**Economic Commission for Europe****Inland Transport Committee****World Forum for Harmonization of Vehicle Regulations****Working Party on Passive Safety****Fifty-fourth session**

**Global technical regulation No. 9 (Pedestrian safety) – Phase 2  
of the global technical regulation****Draft amendment [2]****Submitted by the informal working group on global technical  
regulation No. 9\***

The text reproduced below was prepared by the experts of the informal working group on global technical regulation No. 9 Phase 2 (GTR9-PH2) and proposes provisions on pedestrian safety and motor vehicles. The modifications to the text of the global technical regulation are marked in bold for new or strikethrough for deleted characters.

**Flexible lower legform impactor: Dimensions and centre of gravity locations of femur, knee joint and tibia (side view)**

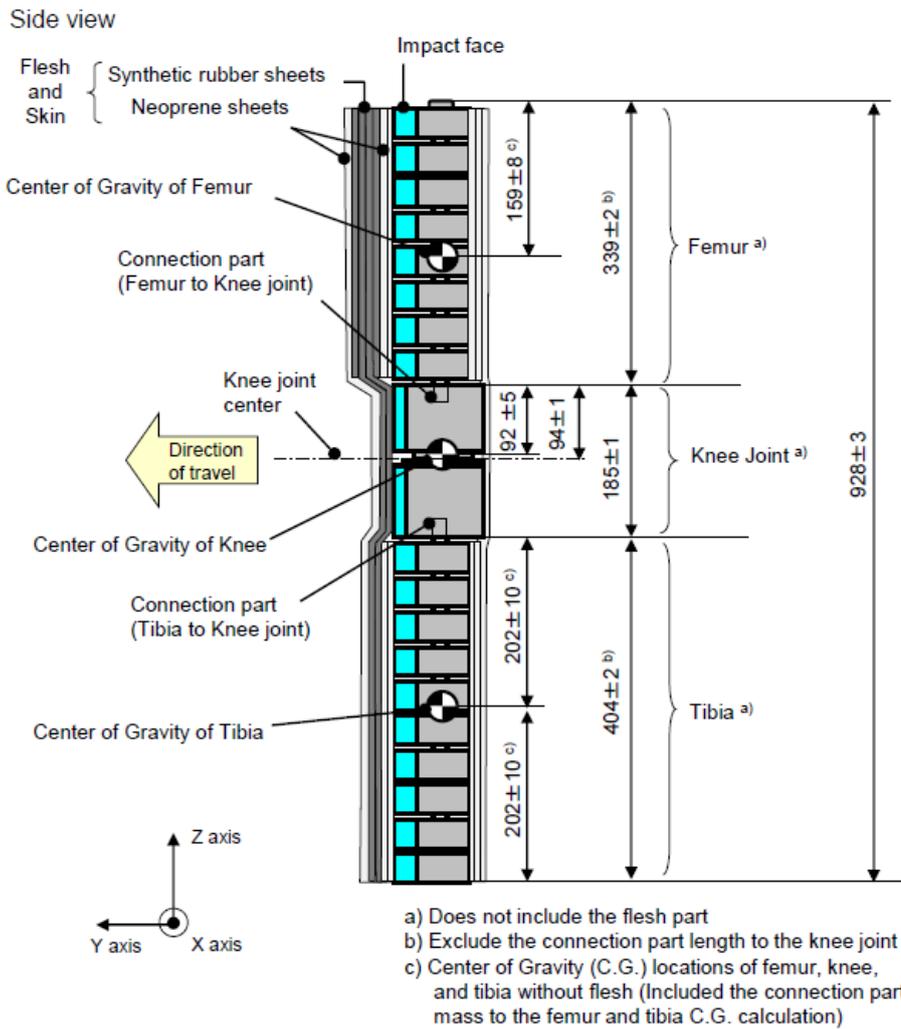
**The flexible lower legform impactor shall consist of the flesh and skin, the flexible long bone segments (representing the femur and the tibia), and the knee joint as shown in Figure 12.**

**The centres of gravity of the femur and tibia without the flesh and skin, including the connection parts to the knee joint, shall be  $159 \pm 8$  mm and  $202 \pm 10$  mm respectively from the top, but not including the connection part to the knee joint, of each part as shown in Figure 12. The centre of**

gravity of the knee joint shall be  $92 \pm 5$  mm from the top of the knee joint as shown in Figure 12.

Figure 13  
**Flexible lower legform impactor: Schematic plan views of femur, tibia, and knee dimensions (top view)**

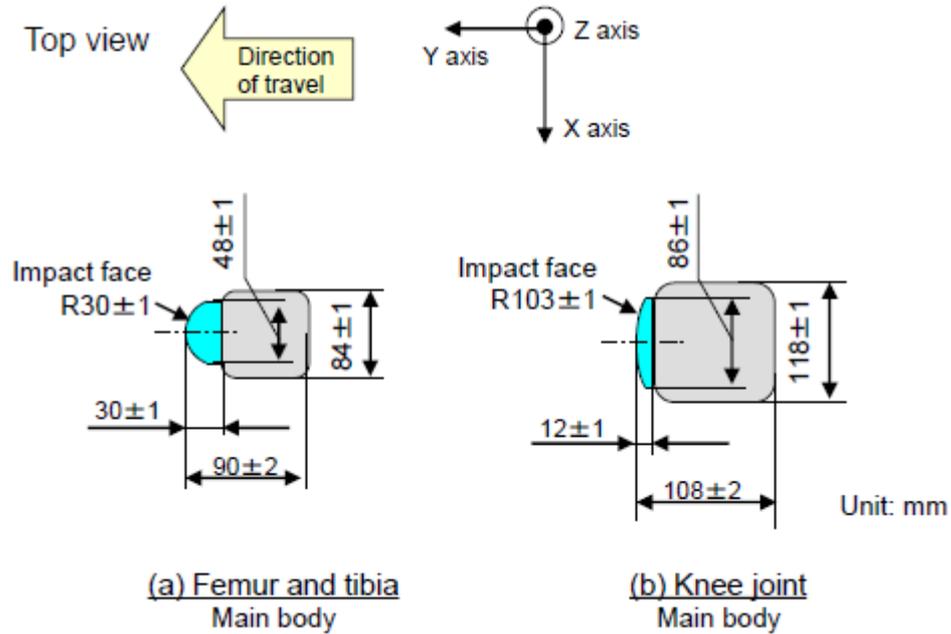
6.3.1.1.1. **The cross-sectional shape perpendicular to the Z-axis of the femur and the tibia main body segments shall be 90 mm in width along the Y-axis, and 84 mm in width along the X-axis as shown in Figure 13 (a). The impact face shall be 30 mm in radius, 30 mm in width along the Y-axis, and 48 mm in width along the X-axis as shown in Figure 13 (a).**

6.3.1.1.2. **The cross-sectional shape perpendicular to the Z-axis of the knee joint shall be 108 mm in width along the Y-axis, and 118 mm in width along the X-axis as shown in Figure 13 (b). The impact face shall be 103 mm in radius, 12 mm in width along the Y-axis, and 86 mm in width along the X-axis as shown in Figure 13 (b).**

Figure 14  
**Flexible lower legform impactor: Flesh and skin dimensions**

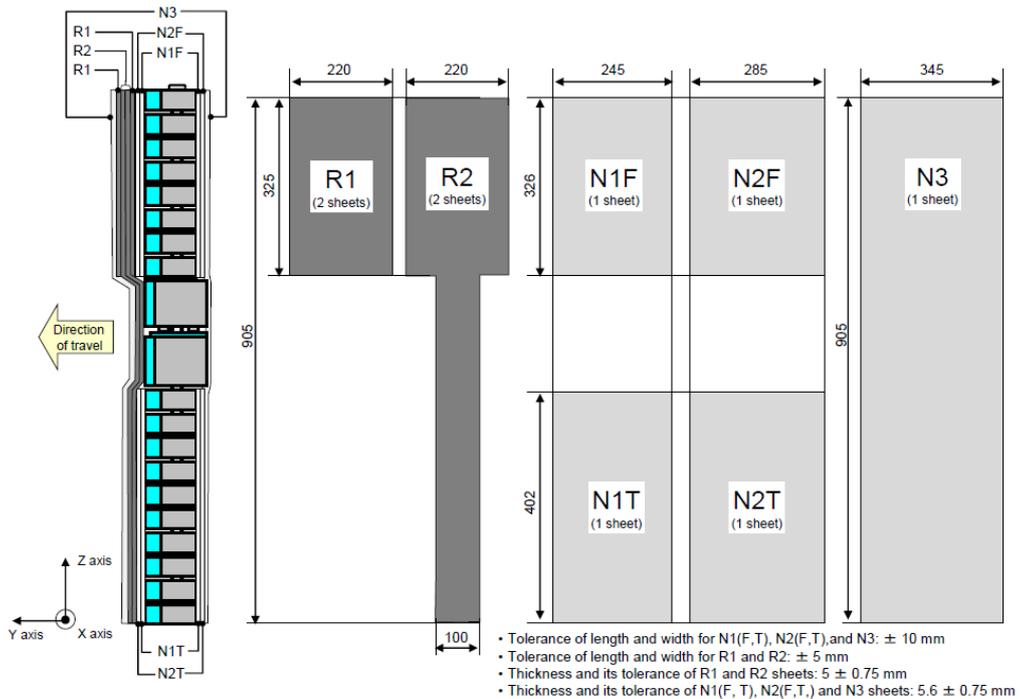
- 6.3.1.1.4. For each test, the impactor (femur, knee joint and tibia) shall be covered by the flesh and skin composed of synthetic rubber sheets (R1, R2) and neoprene sheets (N1F, N2F, N1T, N2T, N3) as shown in Figure 14. The size of the sheets shall be within the requirements described in Figure 15. The sheets are required to have compression characteristics as shown in Figure 15. The compression characteristics shall be checked using material from the same batch as the sheets used for the impactor flesh and skin.

Figure 16  
Flexible lower legform impactor; Instrument

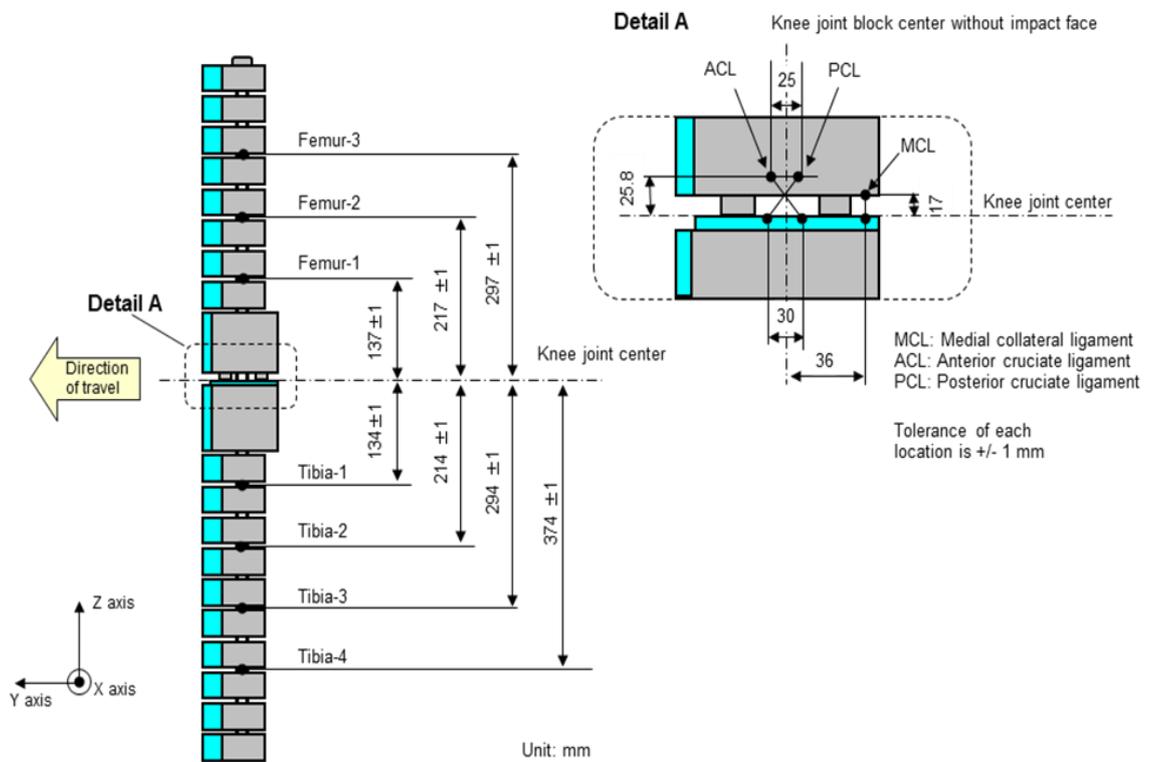
- 6.3.1.1.6.1. Four transducers shall be installed in the tibia to measure bending moments at locations within the tibia. The sensing locations of each of the transducers are as follows: tibia-1: 134 mm, tibia-2: 214 mm, tibia-3: 294 mm and tibia-4: 374 mm below the knee joint centre respectively as shown in Figure 16.

**femur-3: 297 mm above the knee joint centre, respectively, as shown in Figure 16.**

**Tolerances of angles .....**

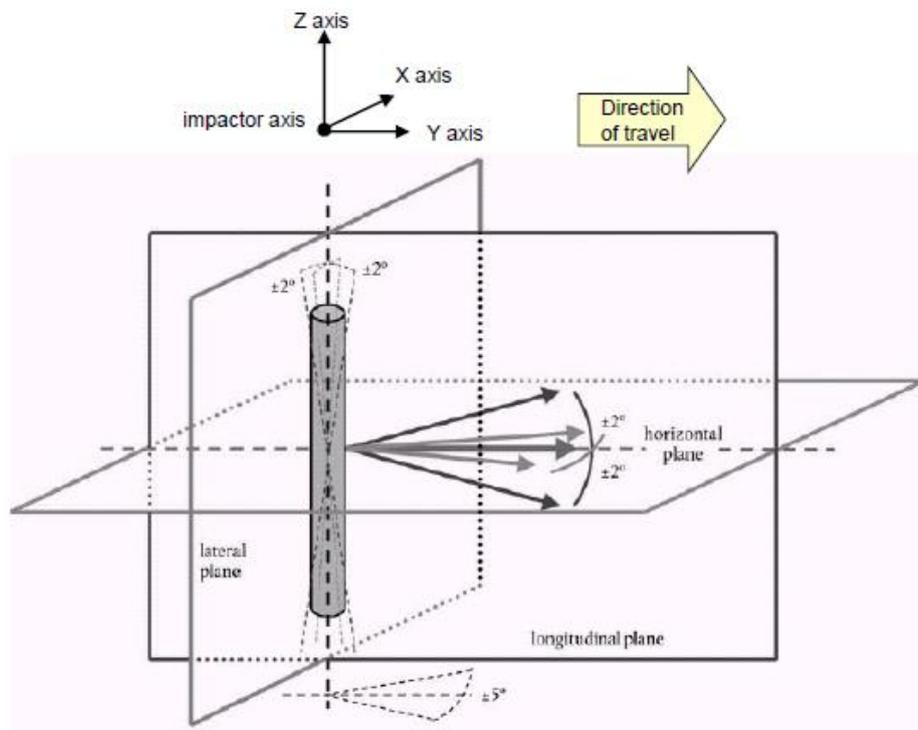
7.1.1.2. **The direction of the impact velocity vector shall be in the horizontal plane and parallel to the longitudinal vertical plane of the vehicle. The tolerance for the direction of the velocity vector in the horizontal plane and in the longitudinal plane shall be  $\pm 2^\circ$  at the time of first contact. The axis of the impactor shall be perpendicular to the horizontal plane, with a roll and pitch angle tolerance of  $\pm 2^\circ$  in the lateral and longitudinal plane. The horizontal, longitudinal and lateral planes are orthogonal to each other (see Figure 20).**

- 7.1.1.3.2. **At the time of first contact the impactor shall have the intended orientation about its vertical axis, for the correct operation of its knee joint, with a yaw angle tolerance of  $\pm 5^\circ$  (see Figure 20).**

**Flexible lower legform impactor** ~~Lower legform~~ to bumper tests for complete vehicle in normal ride attitude (left) and for cut-body mounted on supports (right) (see paragraph 7.1.1.3.)

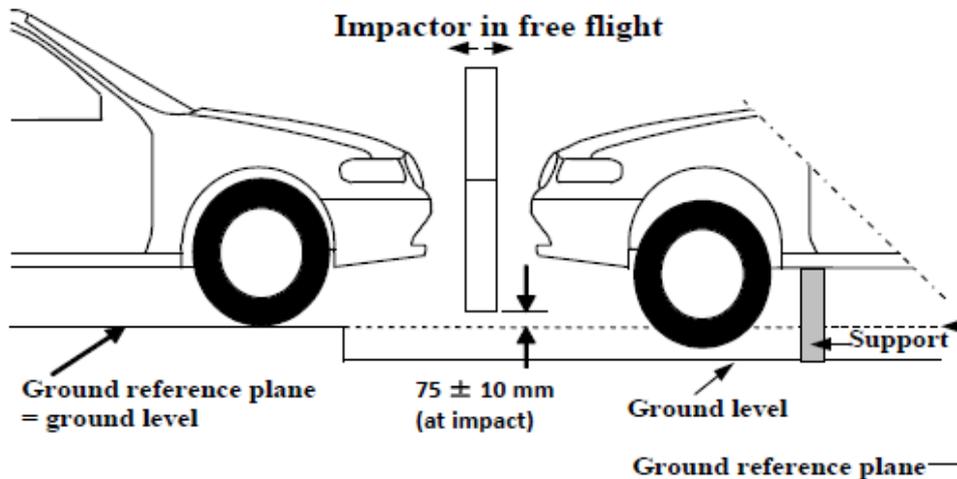
7.1.1.3. **The bottom of the impactor (without parts needed for the purposes of launching and/or protection) shall be 75 mm above the ground reference plane at the time of the first contact with the bumper (see Figure 21), with a tolerance of  $\pm 10$  mm. When setting the height of the propulsion system, an allowance must be made for the influence of gravity during the period of free flight of the impactor.**

**Flexible lower legform impactor: Requirement corridors of the femur and the tibia in the static certification test (see paragraph 8.1.1.2.)**

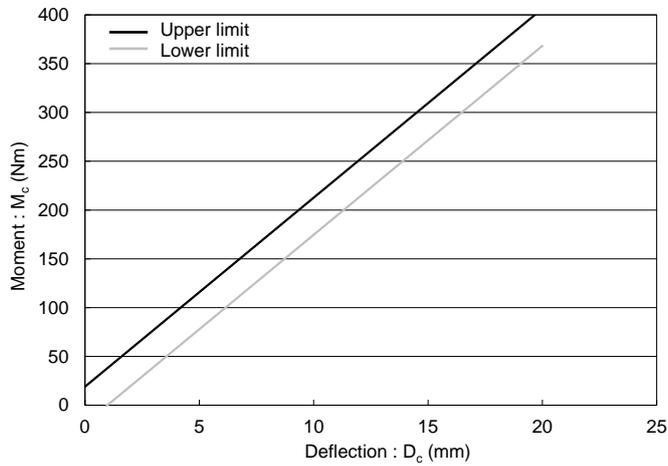
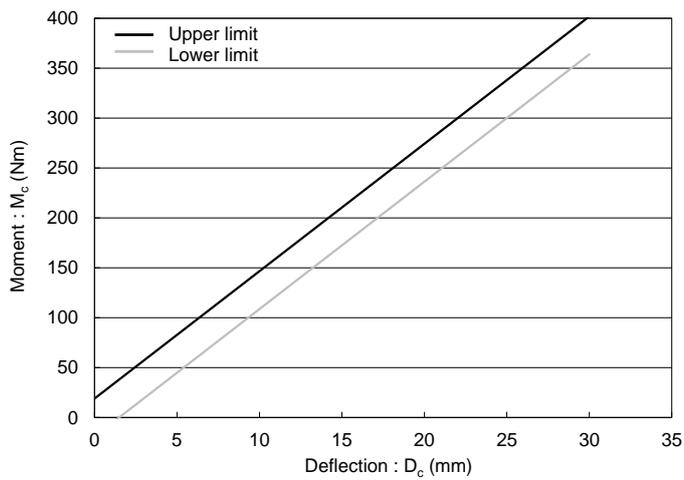
- 8.1.1.2. **When the femur and the tibia of the impactor are loaded in bending in accordance with paragraph 8.1.1.4, the applied moment and the generated deflection at the centre of the femur and the tibia ( $M_c$  and  $D_c$ ) shall be within the corridors shown in Figure 22.**

Figure 23  
**Flexible lower legform impactor: Requirement corridors for the knee joint in the static certification test (see paragraph 8.1.1.3.)**

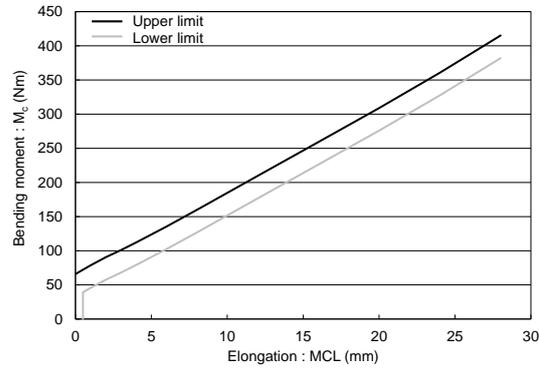
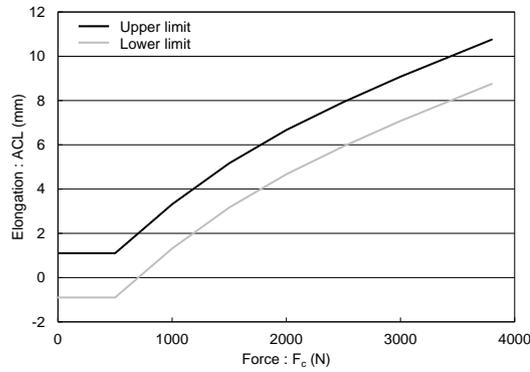
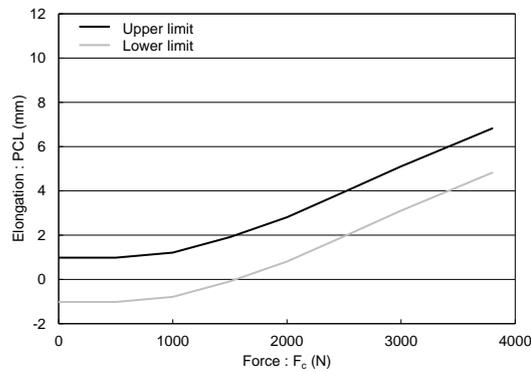
- 8.1.1.3. **When the knee joint of the impactor is loaded in bending in accordance with paragraph 8.1.1.5., the MCL, ACL, and PCL elongations and applied bending moment or the force at the centre of the knee joint ( $M_c$  or  $F_c$ ) shall be within the corridors shown in Figure 23.**

Figure 24  
**Flexible lower legform: Impactor test set-up for the femur in the static certification test (see paragraph 8.1.1.4.)**

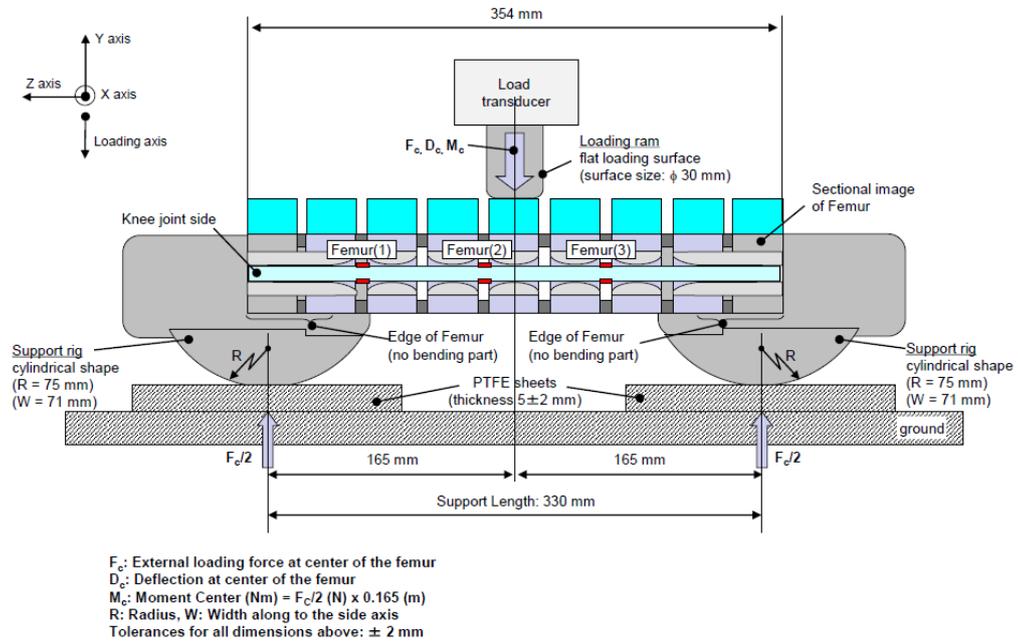
- 8.1.1.4. **The edges of the femur and tibia, not bending parts, shall be mounted to the support rig firmly as shown in Figure 24 and Figure 25. The Y-axis of the impactor shall be parallel to the loading axis within  $180 \pm 2^{\circ}$  tolerance. To obtain repeatable loading, low friction Polytetrafluoroethylene (PTFE) plastic pads are used under each support (see Figure 24 and Figure 25).**

Figure 28  
**Flexible lower legform impactor: Test set-up for the dynamic lower legform impactor certification test (inverse test, see paragraph 8.1.3.4.)**

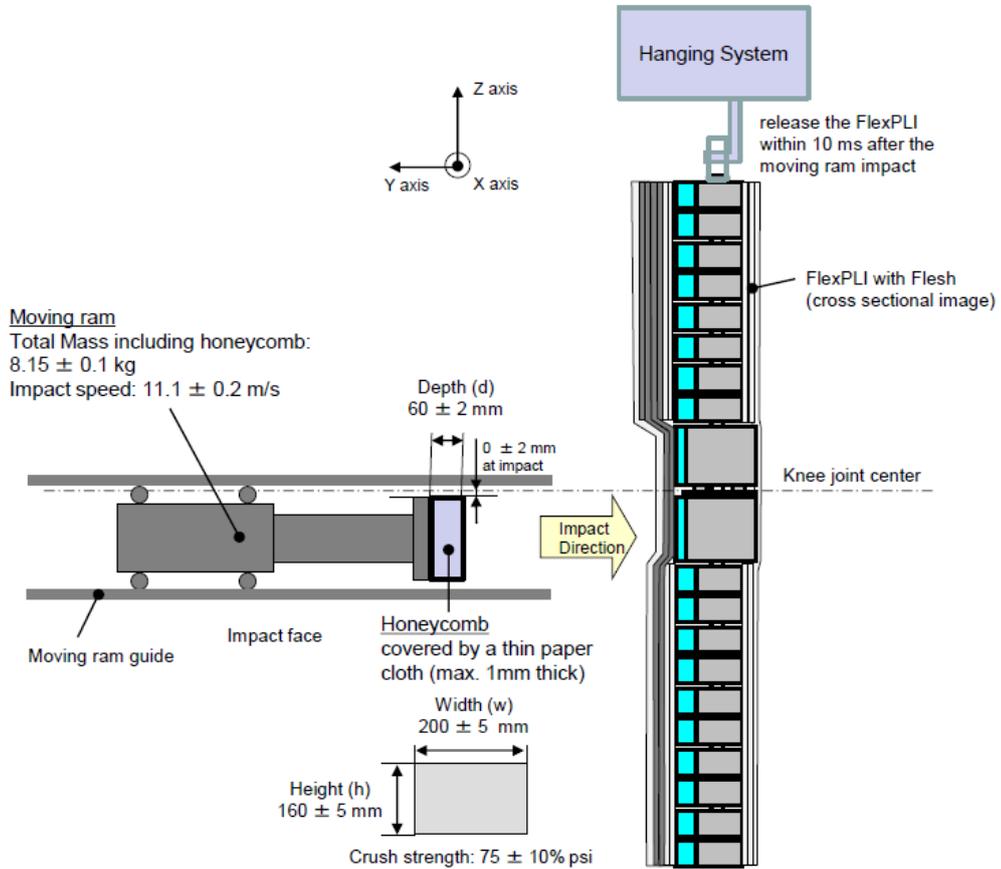
- 8.1.3.4. Test procedure
- 8.1.3.4.1. The assembled flexible lower legform impactor (with the flesh and skin) shall be hung vertically and freely suspended from a test rig as shown in Figure 28. It is then impacted by the upper edge of a linearly guided aluminium honeycomb impactor, covered by a thin paper cloth with a maximum thickness of 1 mm, at an impact speed of  $11.1 \pm 0.2$  m/s. The legform shall achieve a free flight condition within 10 ms after the time of first contact of the honeycomb impactor.
